Project	IEEE 802.16 Broadband Wireless Access Working Group < http://ieee802.org/16 >	
Title	DL-MAP and UL-MAP CID Table IEs	
Date Submitted	2005-01-17	
	Mary Chion Sean Cai Jason Hou Jing Wang Dazi Feng Jun Han Irving Wang	mchion@ztesandiego.com scai@ztesandiego.com jhou@ztesandiego.com
	ZTE San Diego Inc. 10105 Pacific Heights Blvd. San Diego, CA 92121 USA	Voice: 858-554-0387 Fax: 858-554-0894
Re:	Response to Sponsor Ballot on IEEE802.16e/D5a document	
Abstract	The proposed DL-MAP and UL-MAP CID table IEs can be used to not only improve DL subframe efficiency but also significantly reduce unnecessary power consumption.	
Purpose	To incorporate the text changes proposed in this contribution into the 802.16e/D6 draft.	
Notice	This document has been prepared to assist IEEE 802.16. It is offered as a basis for discussion and is not binding on the contributing individual(s) or organization(s). The material in this document is subject to change in form and content after further study. The contributor(s) reserve(s) the right to add, amend or withdraw material contained herein.

DL-MAP and UL-MAP CID Table IEs

Figure 208c. Association for DL-MAP CID Records and DL/UL MAP Data Burst Allocation

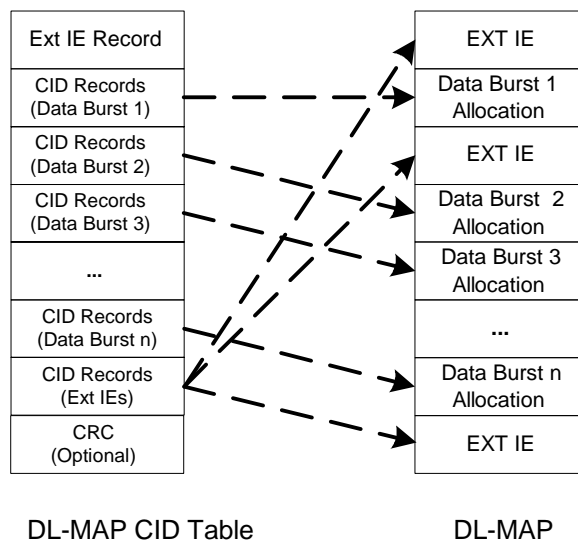
The association of DL-MAP CID table IE records and DL_MAP allocations are shown in Figure 208c.

8.4.5.3.20 DL-MAP CID table IE

Table 284k—DL-MAP CID Table IE

<u>Syntax</u>	<u>Size</u>	<u>Notes</u>
<u>DL-MAP CID table IE () {</u>		
<u>Extended DIUC</u>	<u>4 bits</u>	<u>0x??</u>
<u>Length</u>	<u>4 bits</u>	<u>Length in bytes of following fields</u>
<u>CID Table Sequence</u>	<u>2 bits</u>	<u>00: First page</u> <u>01: Middle page</u> <u>10: Last page</u> <u>11: Single Page</u>
<u>If ("CID Table Sequence" = "00")</u>		
<u>{</u>		
<u> CID Format</u>	<u>2 bits</u>	<u>00: 16 bits</u> <u>01: 12 bits LSB</u> <u>10: 8 bits LSB</u> <u>11: 4 bits LSB</u>
<u> H-ARQ MAP INC</u>	<u>1 bits</u>	<u>0: H-ARQ MAP Pointer IE not included in DL_MAP</u> <u>1: H-ARQ MAP Pointer IE included In DL_MAP</u>
<u> MBS MAP INC</u>	<u>1 bits</u>	<u>0: MBS Service MAP IE not included in DL_MAP</u> <u>1: MBA Service MAP IE included in DL_MAP</u>
<u>}</u>		
<u>Begin CID records</u>		<u>Each CID record contains the list of CIDs. Two types of CID records:</u> <u>Normal CID Record: Each normal CID record contains a list of CID that is corresponding to a allocated data burst in DL_MAP</u> <u>Extended CID Record: Only one extended CID record, it contains the all CIDs that can be included in extended IE.</u>

Figure 208d. Association for UL-MAP CID Records and UL MAP Data Burst Allocation

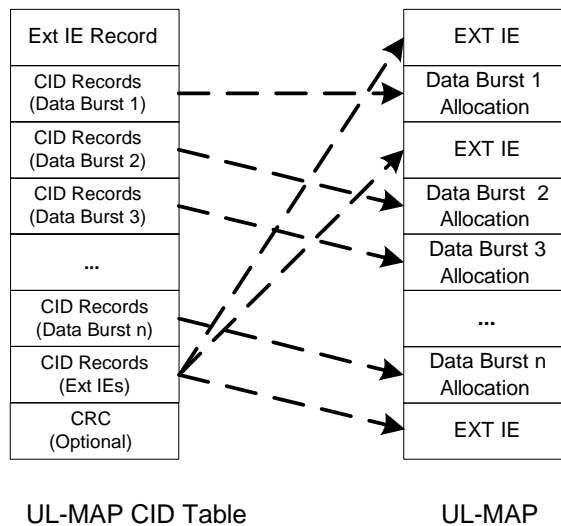
The association of UL-MAP CID table IE records and UL-MAP allocations are shown in Figure 208d.

8.4.5.4.23 UL-MAP CID table IE

Table 284k—Field description of UL-MAP CID table IE

<u>Syntax</u>	<u>Size</u>	<u>Notes</u>
<u>UL-MAP CID table IE ()</u> {		
<u>Extended DIUC</u>	<u>4 bits</u>	<u>0x??</u>
<u>Length</u>	<u>4 bits</u>	<u>Length in bytes of following fields</u>
<u>CID Format</u>	<u>2 bits</u>	<u>00: 16 bits</u> <u>01: 12 bits LSB</u> <u>10: 8 bits LSB</u> <u>11: 4 bits LSB</u>
<u>CID Table Sequence</u>	<u>2 bits</u>	<u>00: First page</u> <u>01: Middle page</u>
